Changes to proposal resulting from Planning Panel Determination

EXECUTIVE SUMMARY- illustrations
 Changes to application
 Response to Clarence Valley Council and Planning Panel
 Determination July 2024

AMENDMENT: Issue 24_07_15	PROJECT: village @james Creek	SCALE: nts	
			TITLE: Response to Refusal reasons -Executive Summary	ISSUE: V3	
			-illustration -cover sheet	DRAWING: 1

CLIENT:	MPD
PROJECT:	village @james Creek
TITLE:	Response to Refusal reasons -Executive Summary -illustration -analysis of previous / revised application

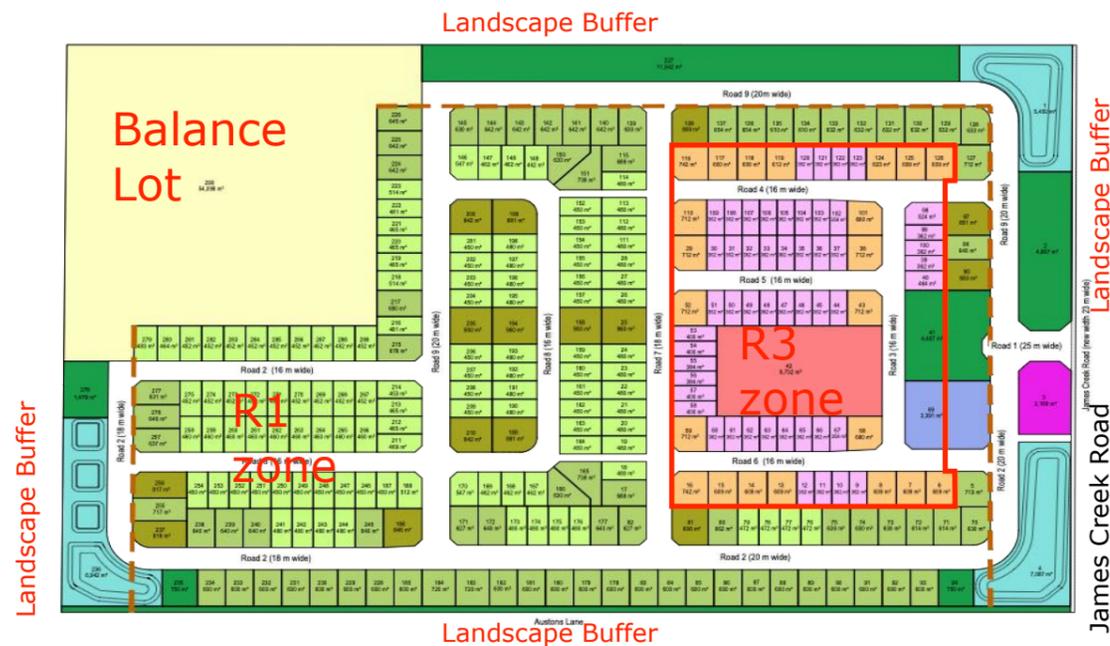
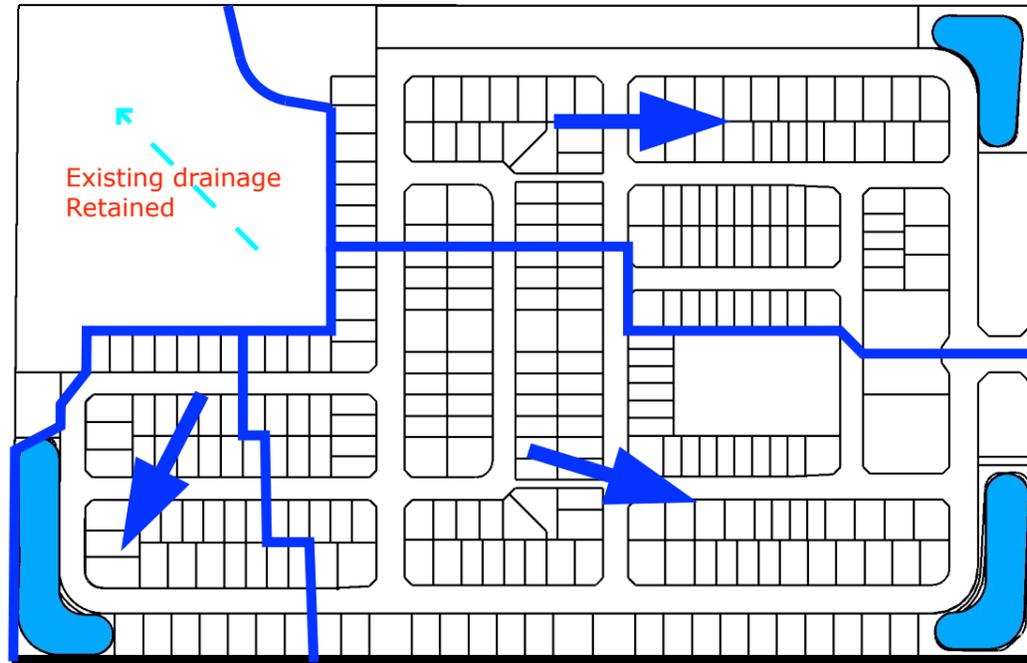
Comparison between previous and current Previous application

The previous design approach was to salt and pepper density throughout the development and to maximise the usage of the zoned land.

Revised application Over arching principle -design changes

- consolidated density to create village community
- add child care (additional social infrastructure)
- located medium density site
- village square
- diversity of residential types
- sense of arrival and community
- soft landscape open frontage to James Creek Road

Plan- revised masterplan illustrating extent of design changes
